## ADDENDUM

No. 01 Date: 8/29/2024  
Project No. 0020711.01 Attention: Leonard D'Souza  
Project Name: Princess Margaret Cancer Centre  
Stem Cell Transplant 2, MHC, MHDU, DSC  
Address: University Health Network  
610 University Avenue  
Toronto ON

*This Addendum forms a part of the Bidding and Contract Documents and modifies the original issued Bidding Documents (dated August 13, 2024) for the above titled project, as indicated below, and is hereby incorporated into the Contract Documents as part thereof.*

**A0502**

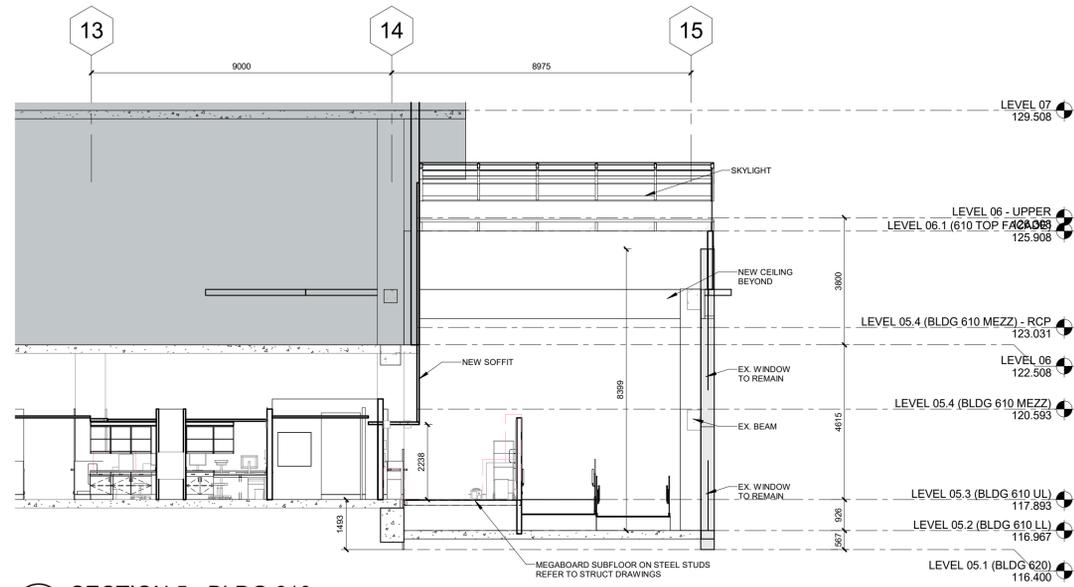
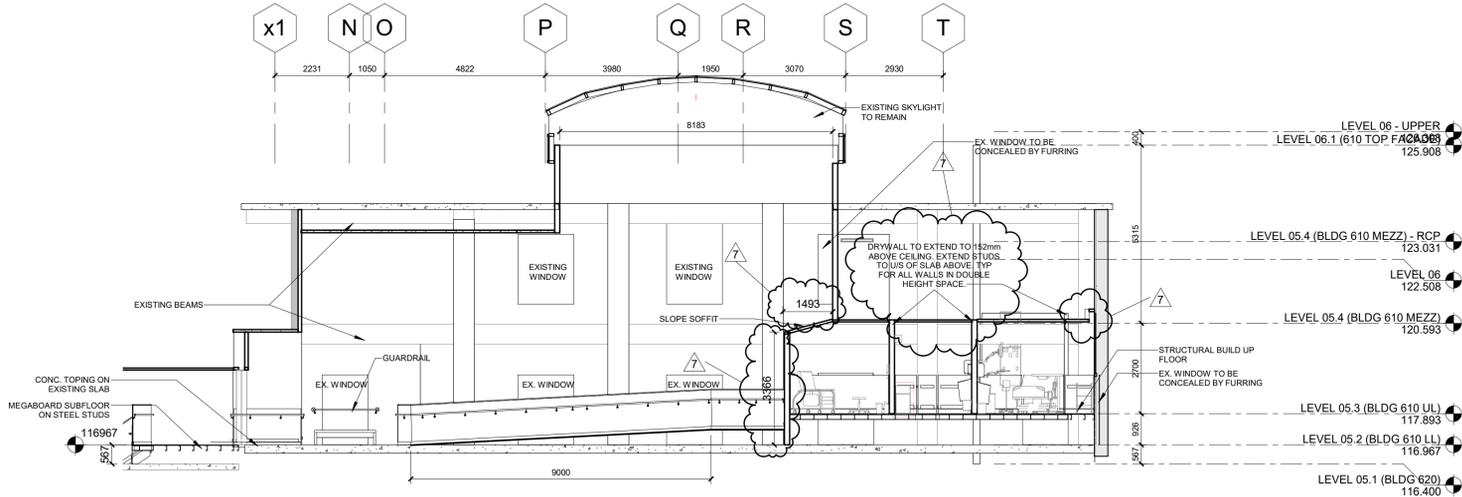
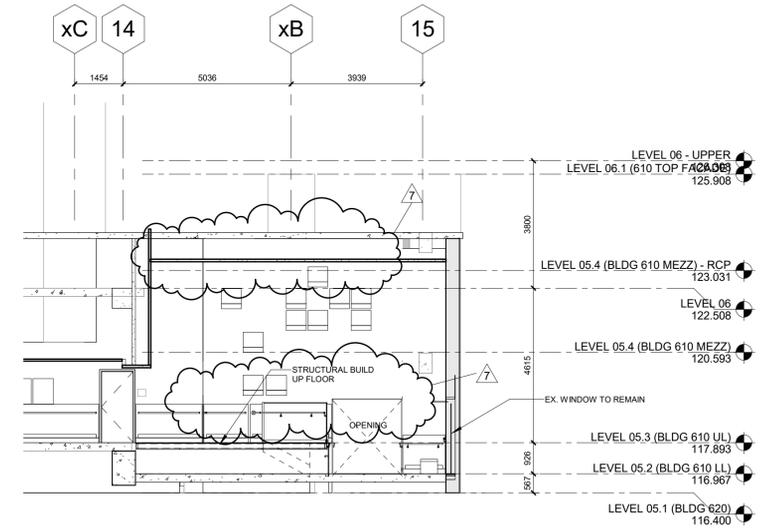
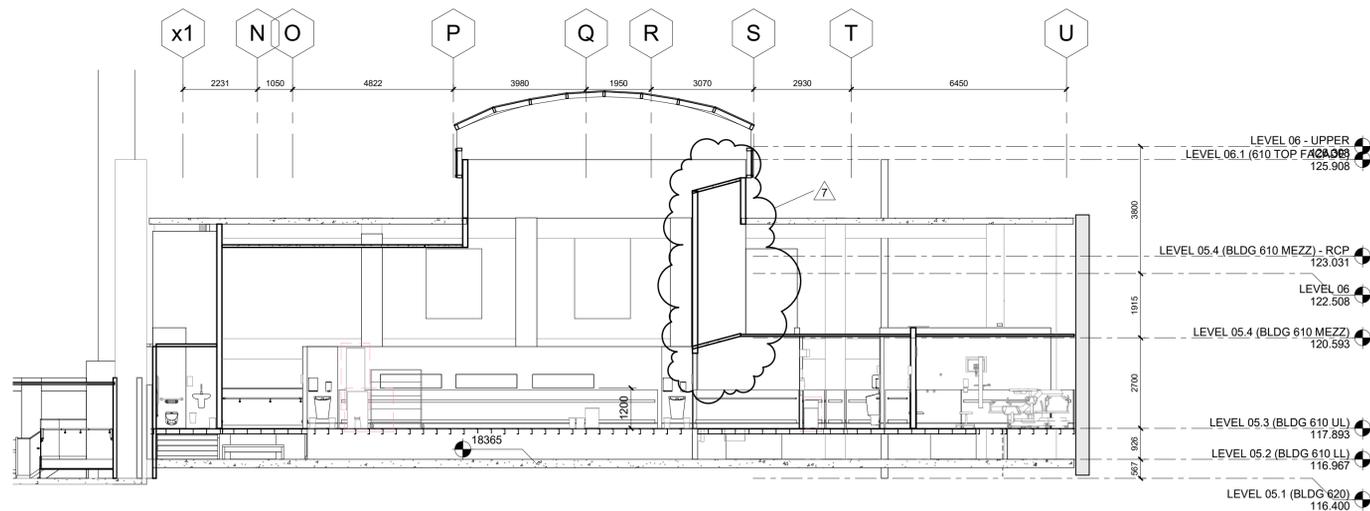
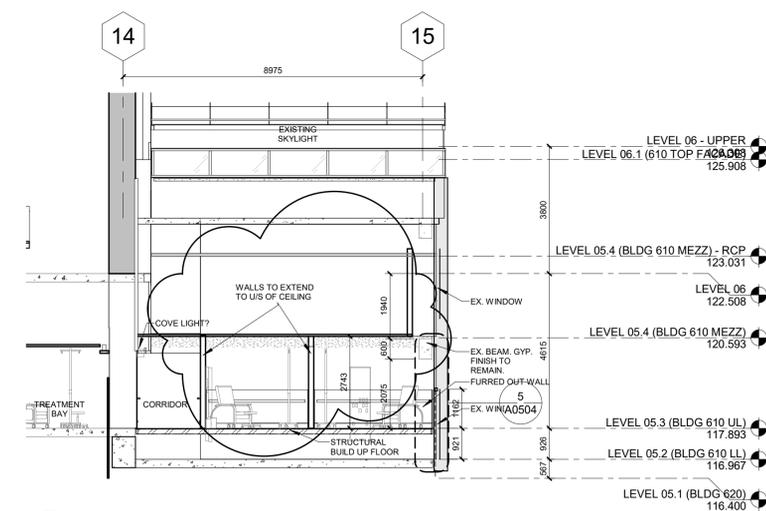
20. Drawing A0502—Building section shows walls with different heights but drawing A004—Interior partition types shows all partitions up to the deck. Can you clarify?

**3. DRAWING A0502 – BUILDING SECTIONS**

**Response: Refer to updated A0502 for wall heights in ramp area**

Added dimensions and notes to show wall heights in the MHDU ramp area.

**EQUIPMENT PLAN -  
LEVEL 2 (MHC)**

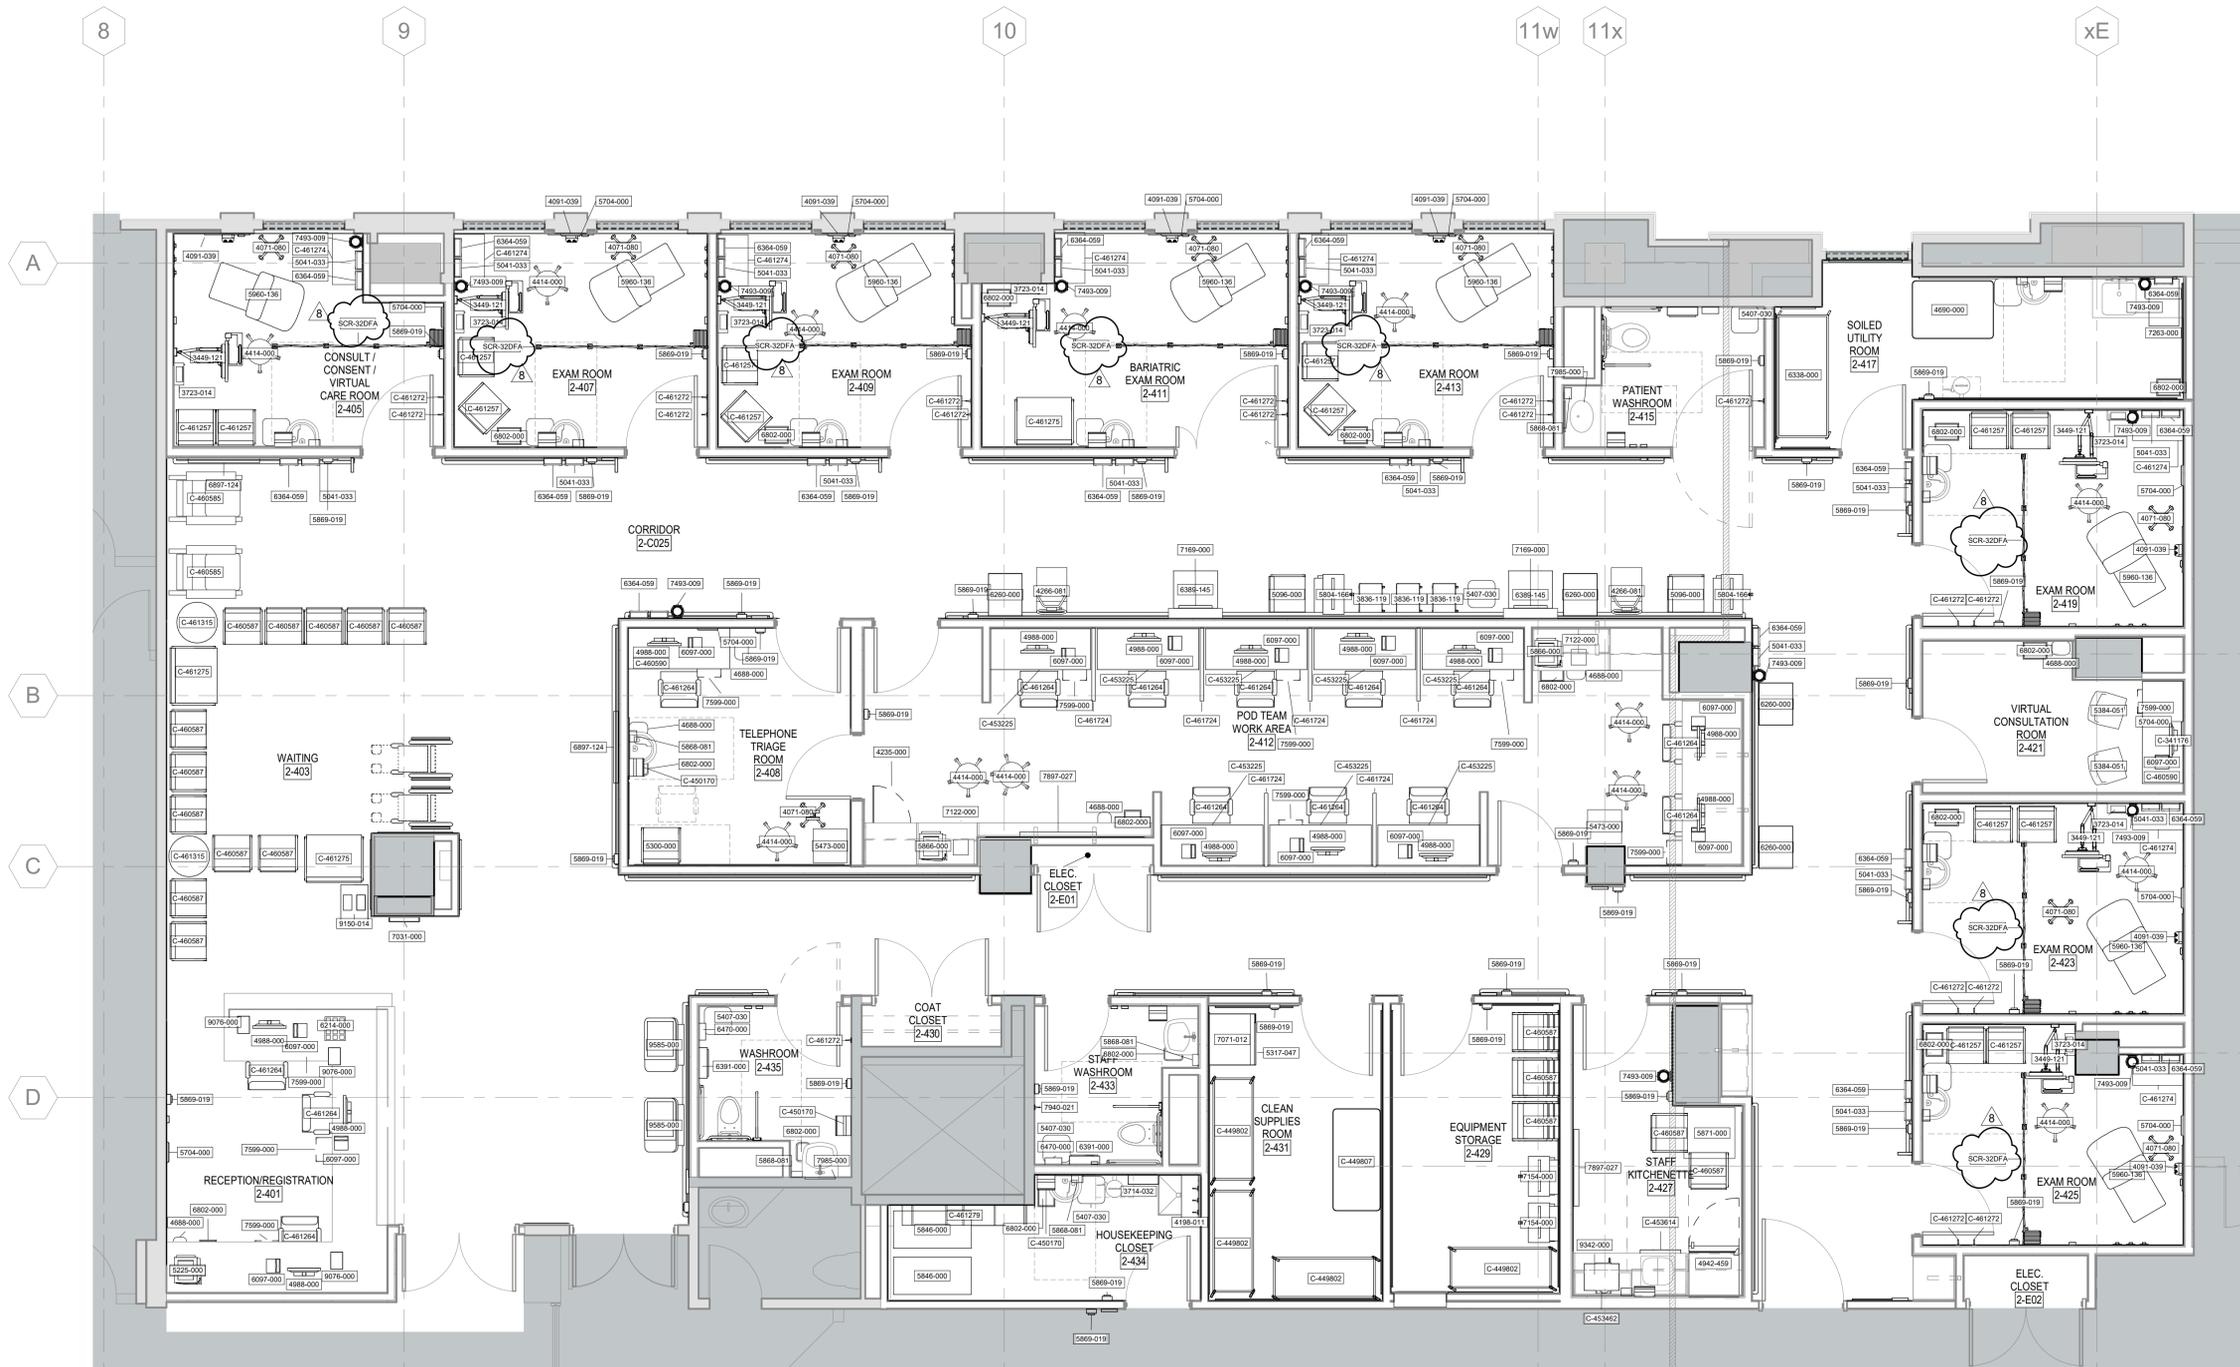
**8. A1102A - EQUIPMENT PLAN - LEVEL 2 (MHC)**

Privacy Screen Tags updated.

**A1105A**

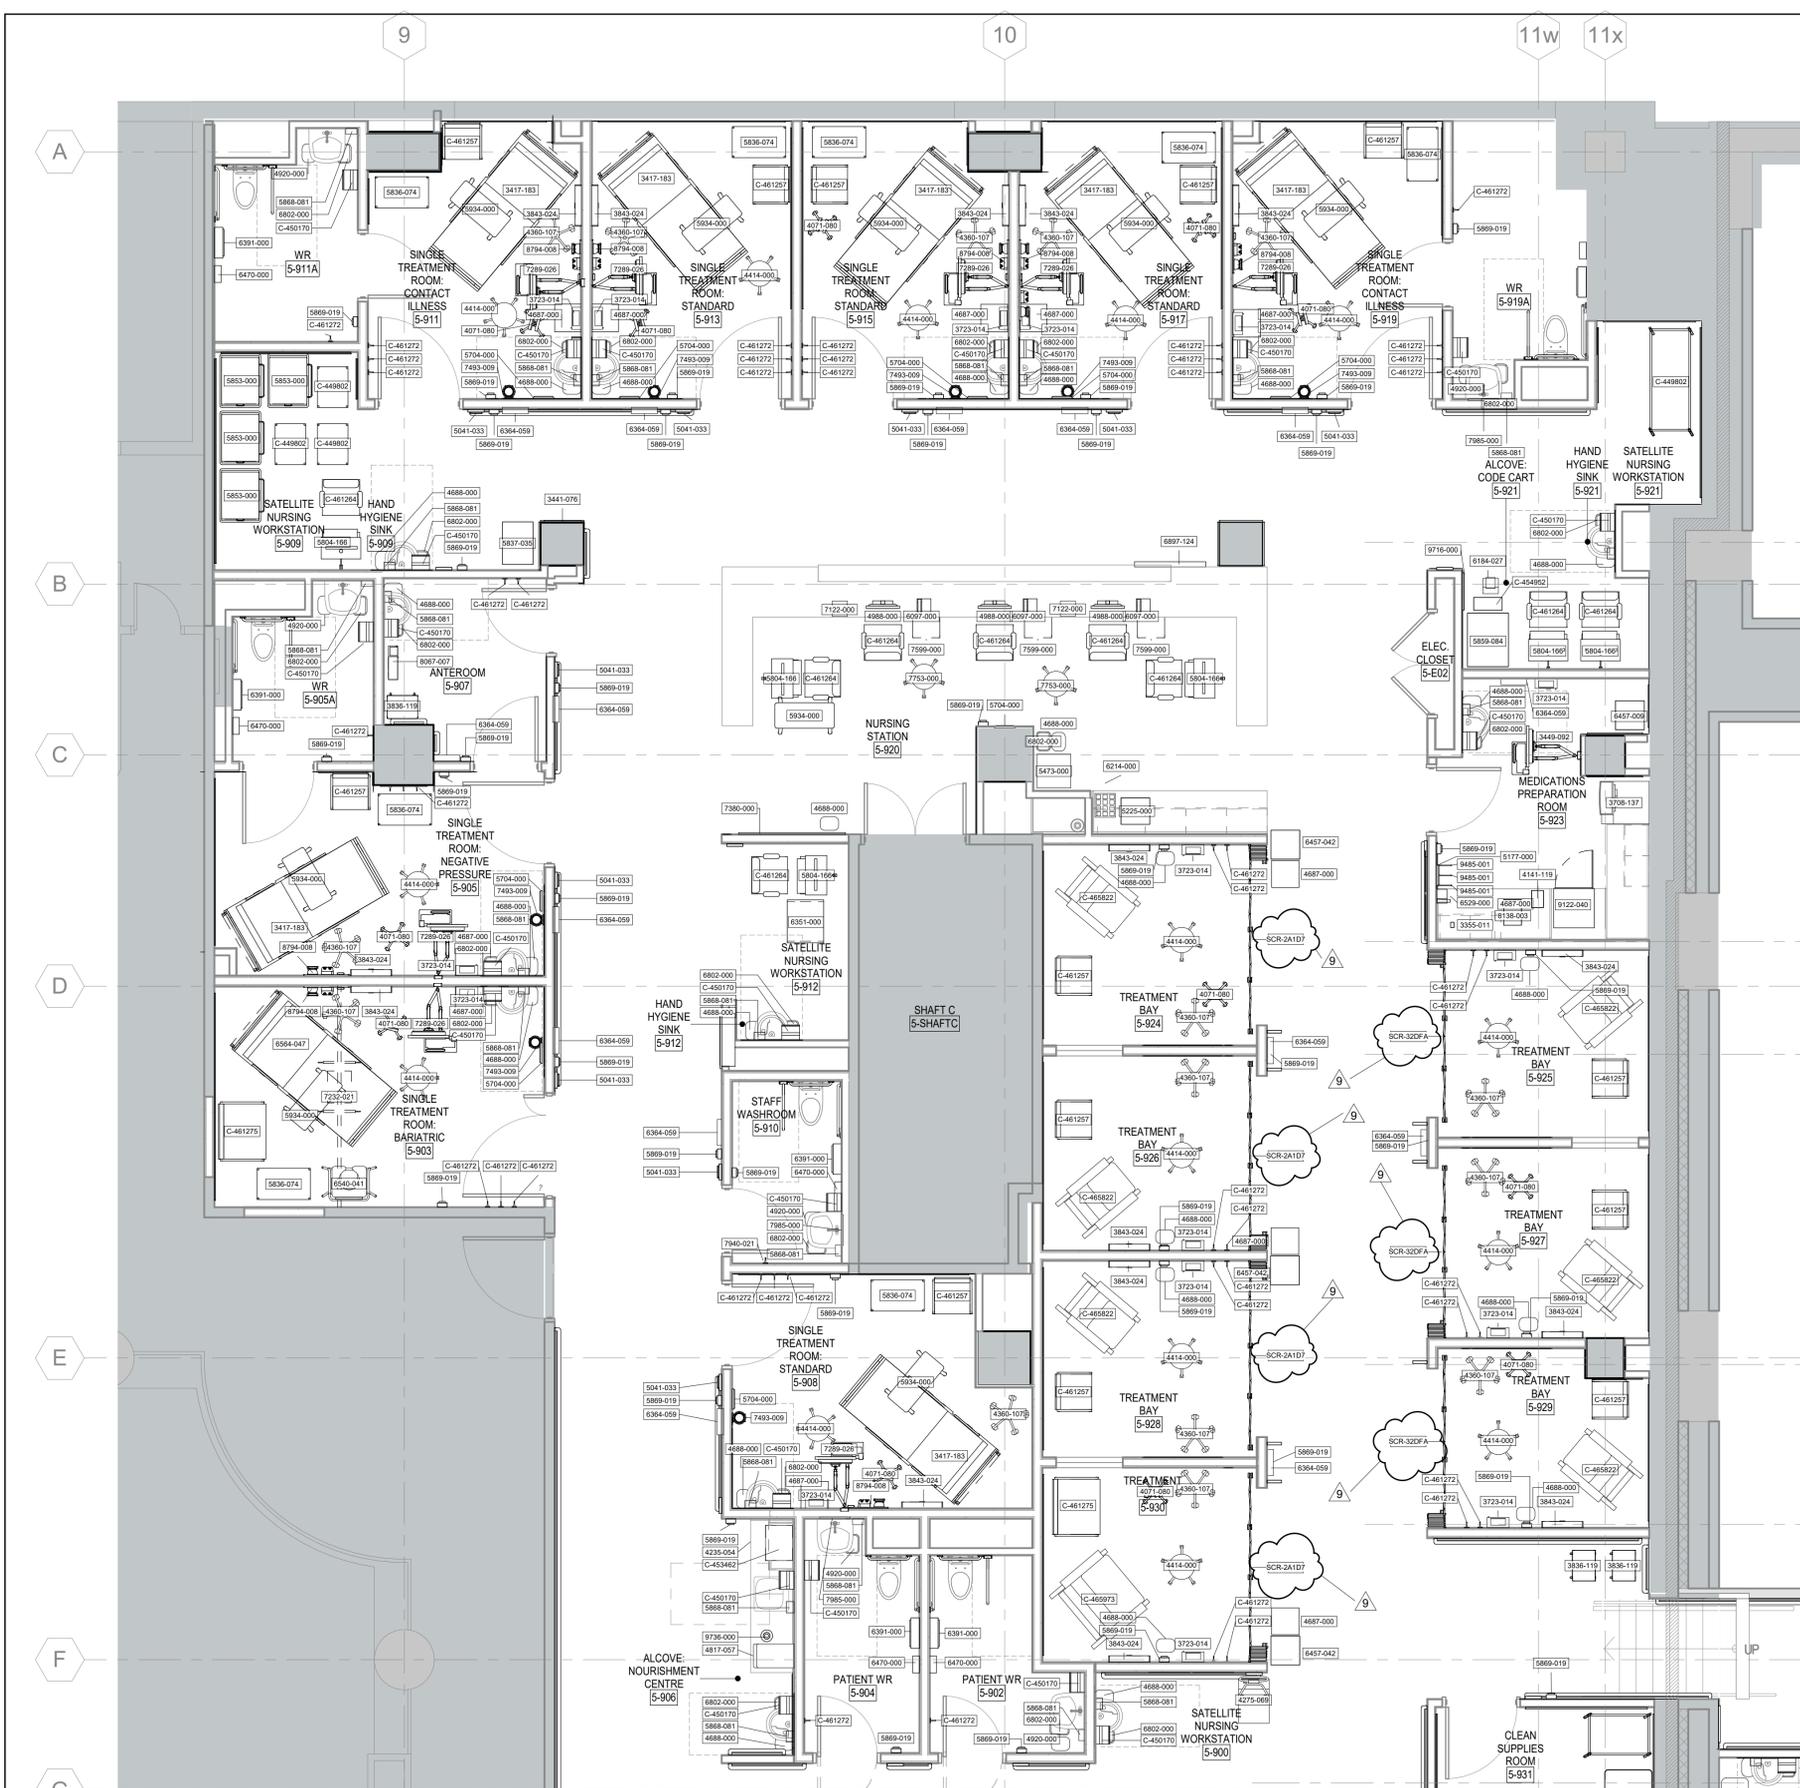
**4. A1105A - EQUIPMENT PLAN - LEVEL 5E (MHDU)**

Privacy Screen Tags updated.
